Westfield Parramatta Shopping Centre Concept Plan Modification 1

Commercial tower modifications

Section 75W Modification Assessment (MP 10_0068 MOD1)

August 2021

Figure 6 | Approved (green) and proposed (blue) tower envelope location (Source: Proponent's RtS)

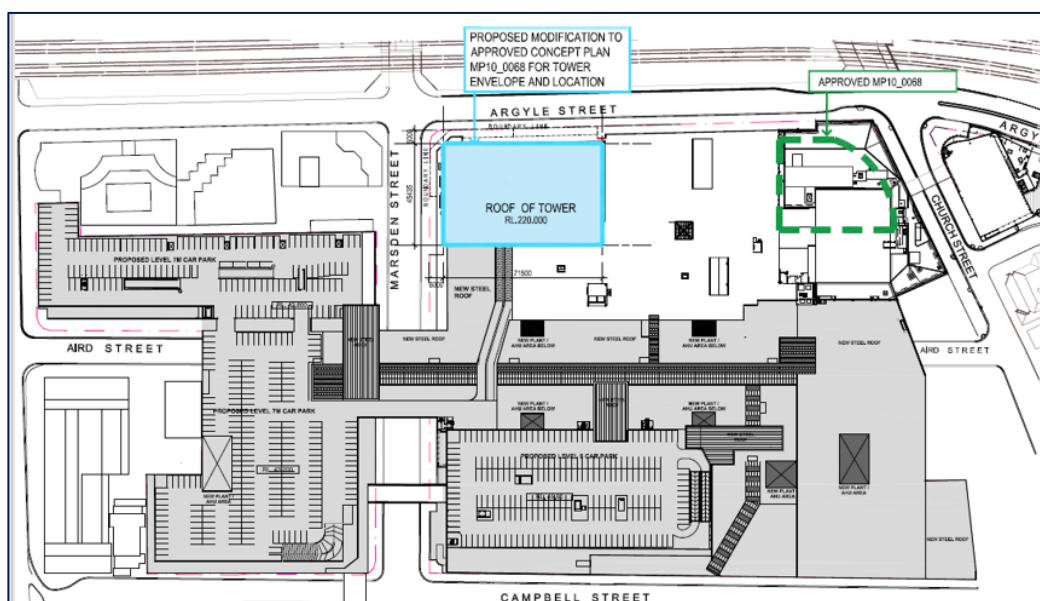
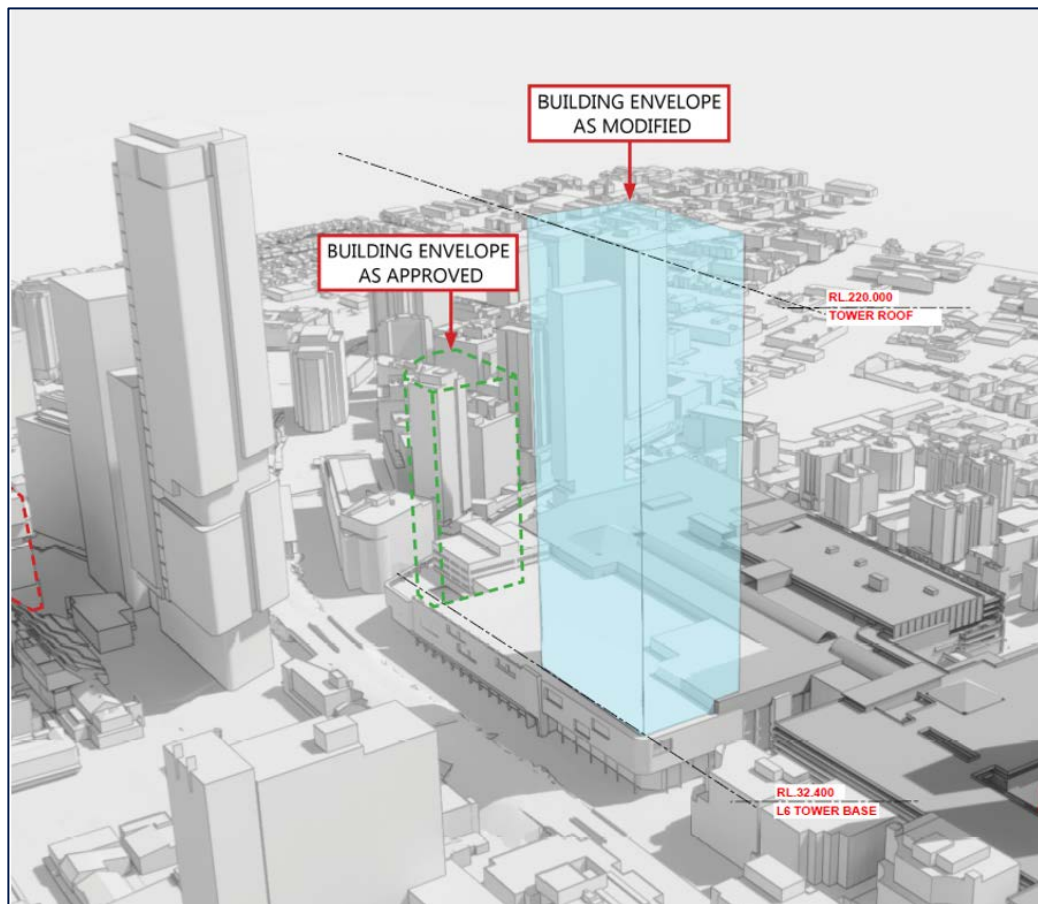
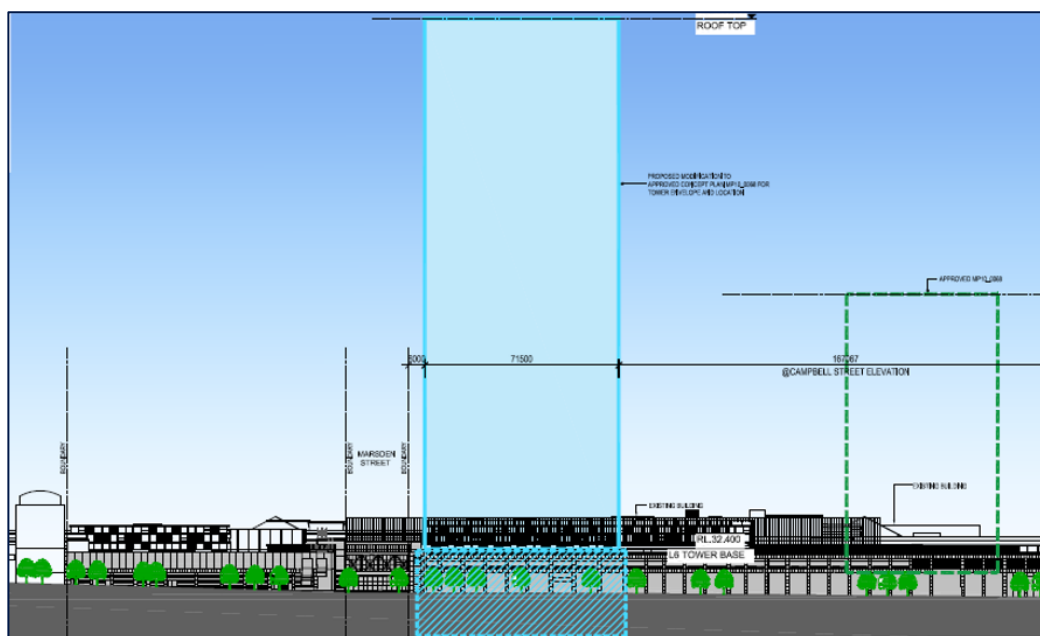
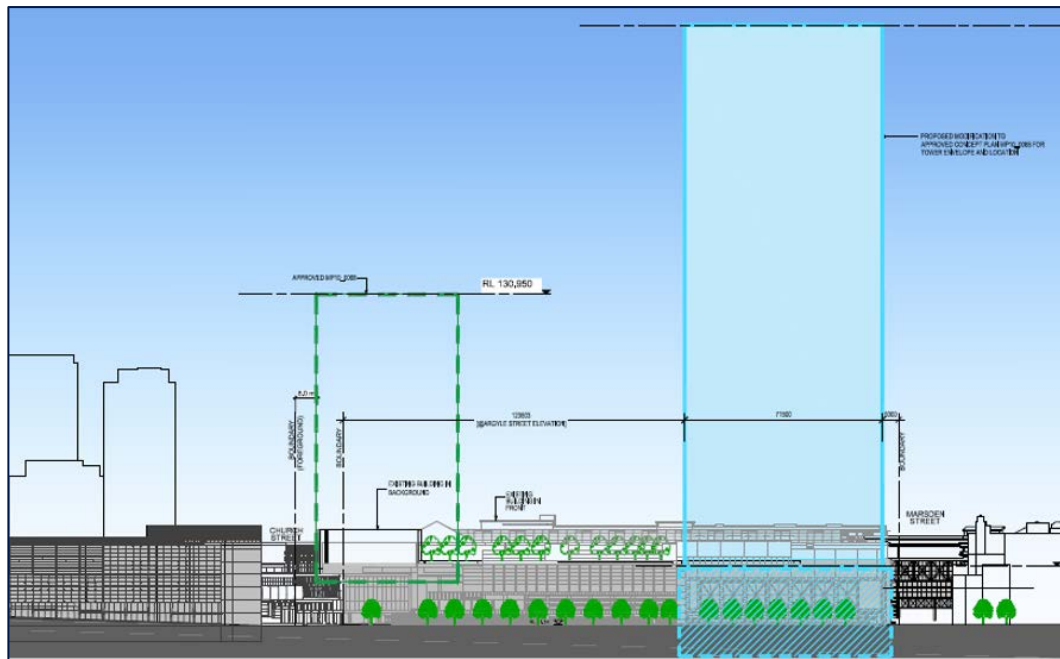
The proposal initially sought to relocate the tower envelope to the middle of the site along Argyle Street and increase the GFA from, 35,000 m² to 112,000 m². In response to concerns raised during exhibition and by the Department, the Proponent amended the proposal to reduce the GFA to 105,000 m² and re-locate the tower further south to the corner of Argyle Street and Marsden Street.

In response the Proponent relocated the tower to the corner of Marsden and Argyle Streets, reoriented the envelope, increased the podium setbacks and reduced the proposed maximum floor space from 112,000m² to 105,000m².

Figure 8 | Draft LEP Building height (211 m) applying to the site and the Approved (green) and Proposed (blue) tower envelope location (Base Source: Parramatta Council Submission)

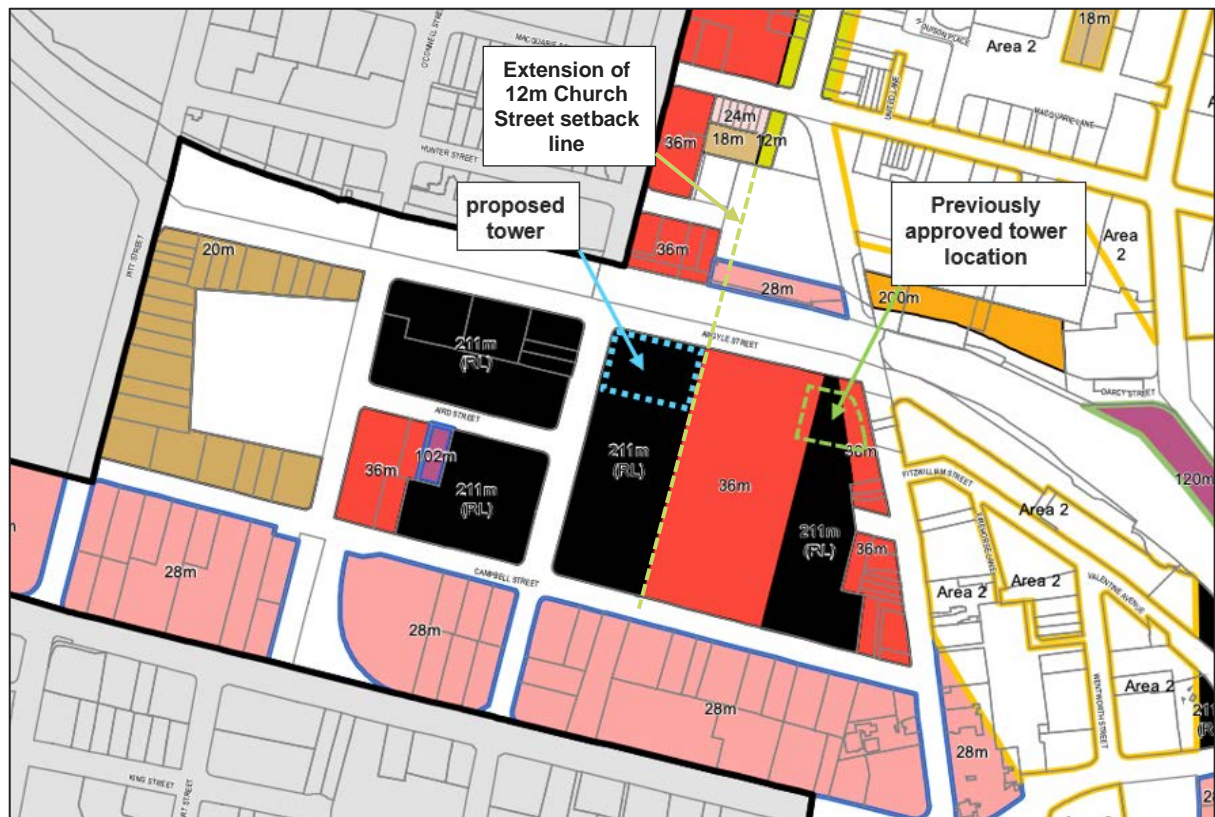
The maximum height permitted on the site under the PLEP 2011 is 36 m. However, the CBD PP would allow a maximum height of RL 211, with a 15% (+31.65 m) height bonus where a design excellence is achieved through a design competition (**Section 3.5** and **Figure 8**). This would allow a maximum permissible height of RL 240.65 m.

- it preserves the low scale heights (maximum 36 m) along Church Street and within the Church Street view corridor by relocating the previously approved tower which encroached into these areas (**Figure 8**)

Figure 10 | Proposed building in the context of emerging surrounding building heights (Base Image Source: Urban Design Report, RTS)

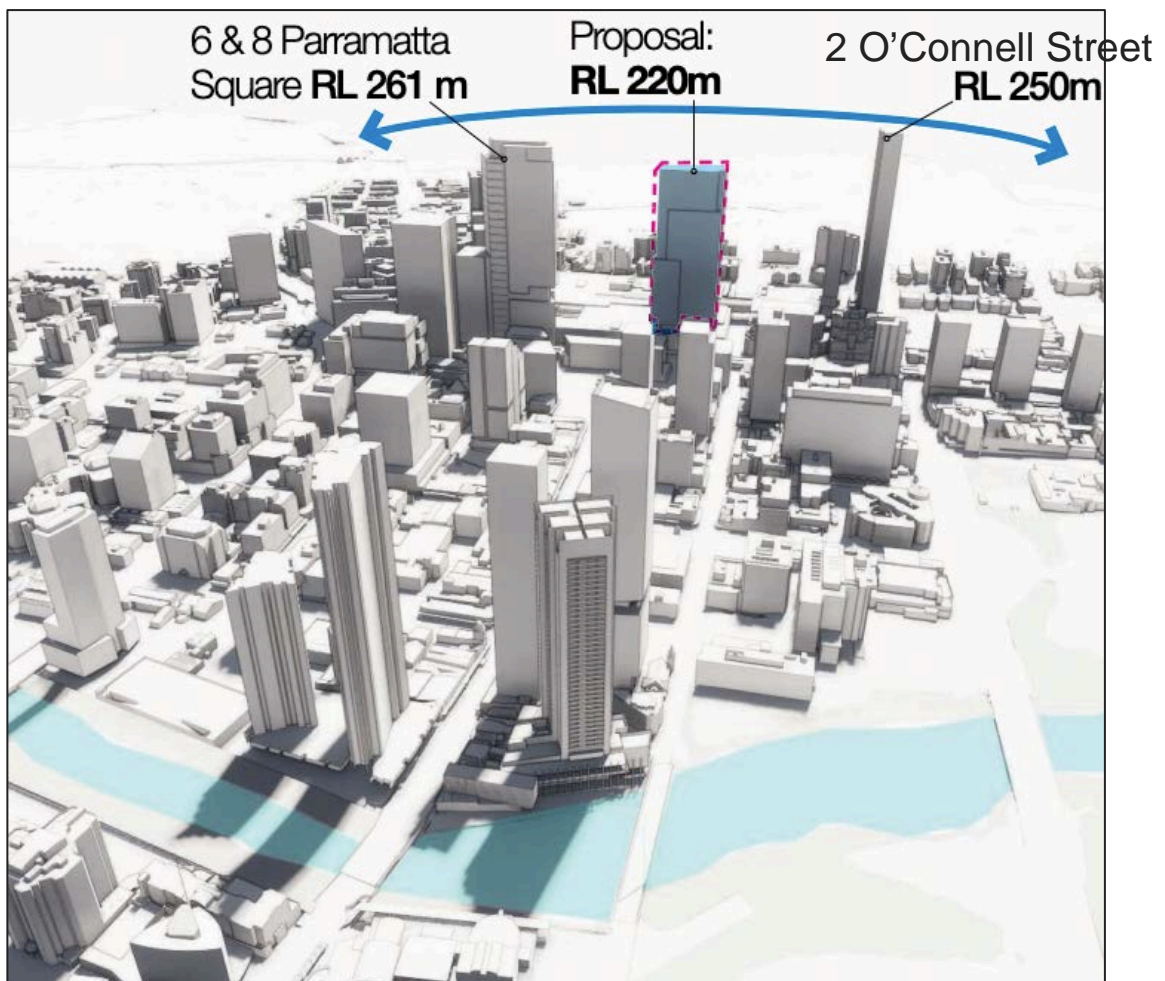
- it would be compatible with emerging building heights within the Parramatta CBD, including the recently constructed commercial tower (RL 261 m) at 8 Parramatta Square and the Planning Proposal approved for a maximum height of RL 250 at 2 O'Connell Street (**Figure 10**)

Figure 2 | Potential size of the future tower in the context of other CBD buildings (Base Image Source: Visual Impact Assessment, RTS)

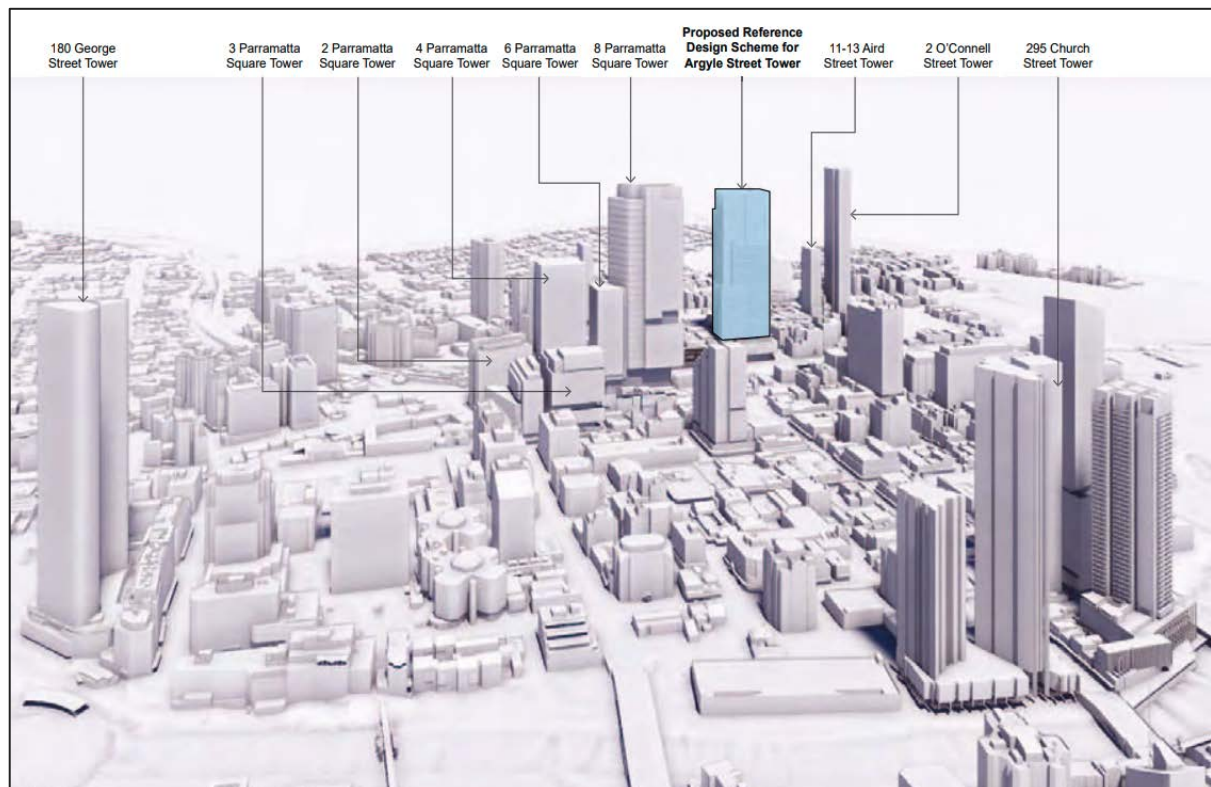
Council and GANSW raised concerns about the size of the floor plate, in particular the proposed 71.5 m building envelope length. Council acknowledges the unique characteristics of the site, however it recommended the floorplate be limited in size to provide an appropriate built form in this location. Council advises the Draft DCP that is currently being developed would limit floor plates in the CBD to 2,500 m² and façade widths to 60 m in length.

GANSW also noted that existing commercial buildings in the CBD, with similar floorplates are generally much shorter, and there is only one other similar building at 8 Parramatta Square and it has smaller overall dimensions and a slightly smaller floorplate than the current proposal. GANSW therefore recommended that built form controls should specify that the GFA not occupy more than 70% of the Maximum Planning Envelope and that building frontages should not exceed 60 m.

However, the proposed tower envelope would be the largest and widest tower of this height in the Parramatta CBD. It would also be highly visible from numerous locations within and around the CBD (**Figure 11**) including distant views from the north and south as well as from Old Government House and The Domain. The Department also notes that while the tower is separated from nearby towers, the CBD PP would allow towers up RL 211 (or RL 240.65 with the design excellence height bonus) on

other portions of the Westfield site and sites fronting Argyle Street (**Figure 8**) which could significantly alter the surrounding site context in the future.

The Department therefore considers it critical that the future building within the envelope limit the visual bulk of the tower and closely align with Council's emerging controls for the CBD. The Department therefore recommends:

Figure 3 | Proposed location of the tower in the context of The Church Street View Corridor (Base Image Source: RTS)

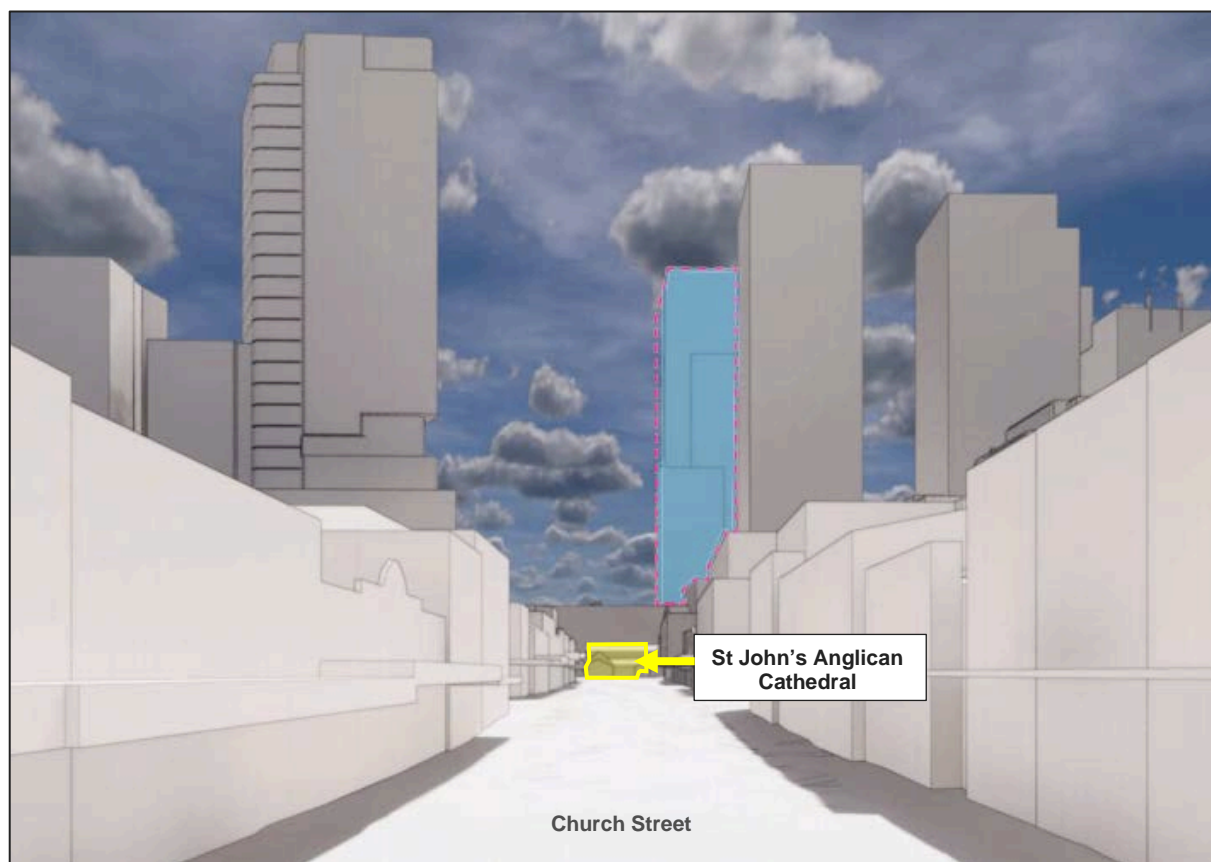
The Church Street view corridor is a City Centre Historic View identified by PDCP 2011. The view corridor will be formalised and protected in the CBD PP with a setback of 12m from the boundaries of Church Street. St John's Anglican Cathedral is located within the view corridor (**Figure 8 and 12**).

The proposed building envelope is setback of 12m from the alignment of Church Street and therefore would be clear of the view corridor established by the CBD PP (**Figures 8 and 12**).

Council advised the tower envelope appears to be broadly consistent with the proposed CBD PP controls but advised the final alignment will need to be confirmed with accurate CAD drawings.

Figure 4 | View from in front of Old Government House (Base Image Source: HIA) (Note: image also includes the initially proposed envelope (in the EA) in light blue)

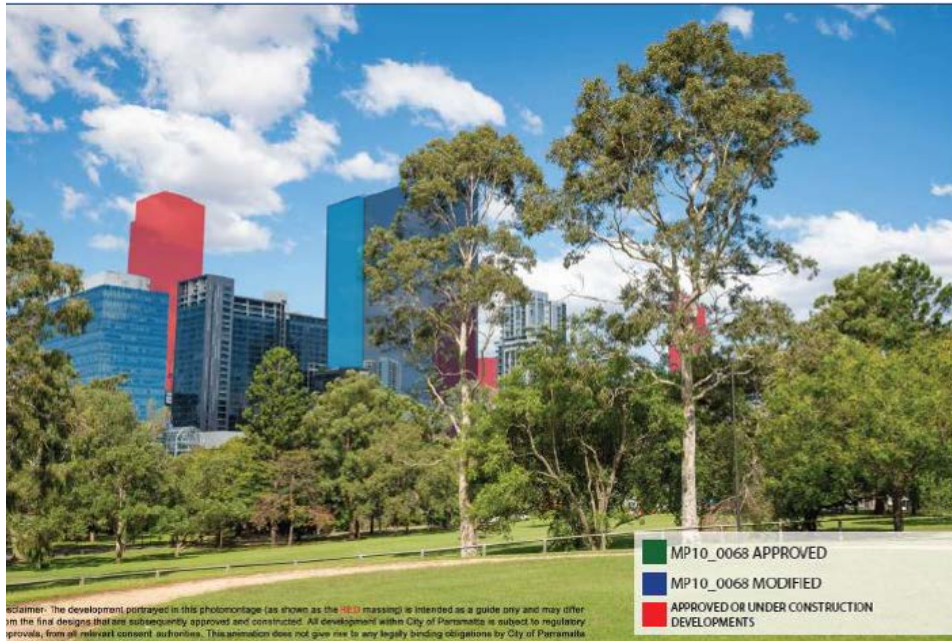
Council and Heritage NSW raised concerns with the potential visual impact of the tower on OGHD located in Parramatta Park, which is included on the National Heritage List and on UNESCO's World Heritage List. Heritage NSW advised that if the modification is approved, conditions should be included to ensure tower materials, finishes and design minimise the visual dominance and reflectivity of the tower in relation to OGHD and external signage should be designed to minimise visibility from OGHD.

The HIA notes the modified envelope is located within the sensitive view zone from Old Government House classified in the Planisphere Report as a 'High significance view'. However, the HIA concludes the proposal would not cause any significant visual impacts on the composition of views from OGHD, noting it will be visible in the context of other similar building forms forming part of the city skyline of buildings present and proposed in the CBD (**Figure 13 and 14**).

The Department has considered the concerns raised by Heritage NSW and Council and the guidance provided within the Planisphere report. The Department considers the visual impacts of the proposal from OGH are acceptable as:

- the proposal is consistent with the Planisphere development guidelines as it:
 - locates a tall tower within the city central precinct reducing its prominence in the skyline

- will provide a well-proportioned visually interesting design subject to FEARs limiting the tower length and volumetric fill to ensure a suitably articulated and elegant final building form which can achieve design excellence

- aligns with the street grid reinforcing the formal layout of the Georgian Town plan
- the future building, located approximately 600 m from Old Government House, would be read as part of the city skyline which makes up the background of the views
